Technical Service Bulletin

96 Lane change assist: side assist and exit warning system: unavailable. Sensor view restricted (DTC C12AA00)

91 24 01 2073683/1 April 16, 2024.

Model(s)	Year	VIN Range	Vehicle-Specific Equipment
RS 6	2021 - 2024	All	Not Applicable

Figure 1: Illustration showing positioning of holes for spreader rivets.

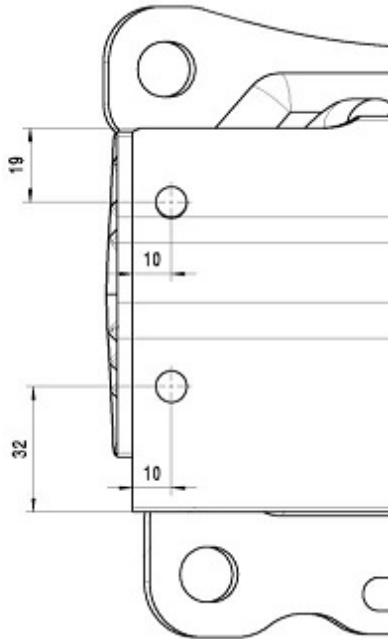
In order to secure the covers, two holes (8 mm diameter) must be drilled on each side (left and right) of the bumper cover, as shown in the image below:

Cover the holes and openings on both sides of the bumper carrier. To do so, please use the following covers:

Please use the following spreader rivet to secure the covers on the bumper carrier:

- N 905 584 01 (2x per side)
